Thor Motor Coach Recall Repair Instructions

Recall #	14V-		
Description/Title:	Outlaw 29H Generator Exhaust Pipe Replacement		
Affected Product Line(s):	Certain Outlaw 29Hs Offline between 1/13/2014 and 4/25/2014.		
Service Campaign # :	RC000089	Released Date:	
Failure Code:	TMCRC80435V	Document Date:	
Time Allowed:	0.5	Document Revision:	A

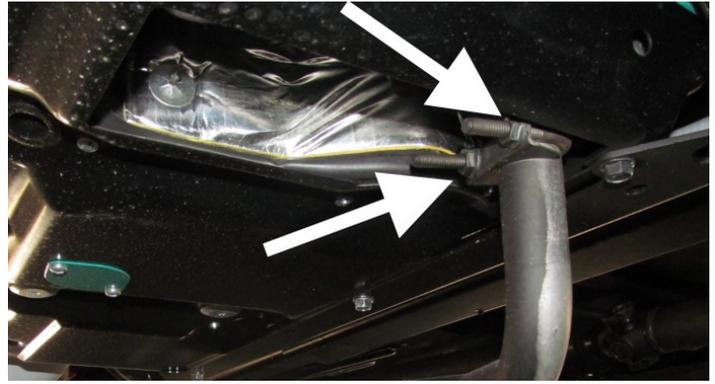
SUMMARY: On certain Outlaw 29H units, the existing generator exhaust pipe is too close to the LP tank.

CONSEQUENCE: This is a code violation that potentially could result in a fire. In the event of a fire, there is a potential for property damage, personal injury or death.

Determine whether the unit has the old or new generator tail pipe by going to the driver's side of the unit and finding where the generator exhaust pipe is located. If it is between the first and second compartment door, a new generator exhaust pipe will need to be installed. If it is between the 3rd compartment door and the wheel well, the recall does not need to be performed.

REMEDY: Thor Motor Coach will install a new generator exhaust tail pipe that routes away from the LP tank.

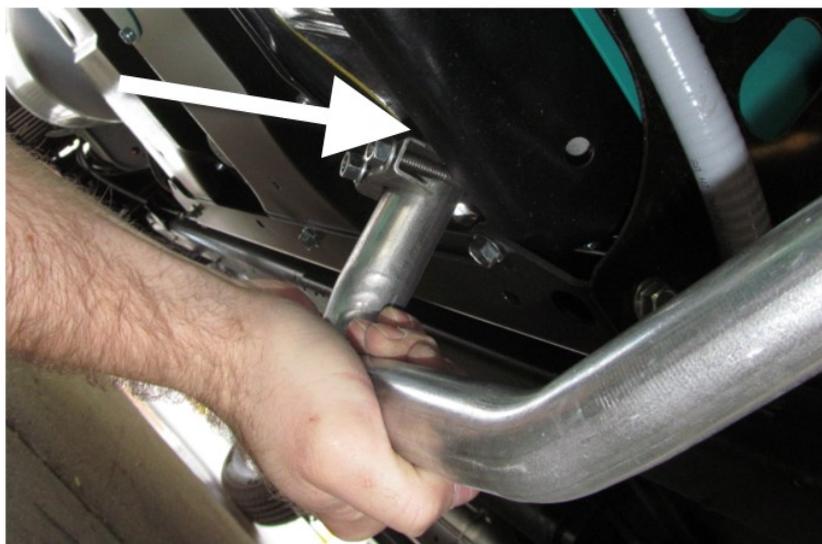
4. Orient the new exhaust pipe to match the following picture.

5. Install the tailpipe clamp onto the end of the new exhaust pipe that will be attached to the generator.

6. Install the hanger on the other end of the new exhaust pipe.
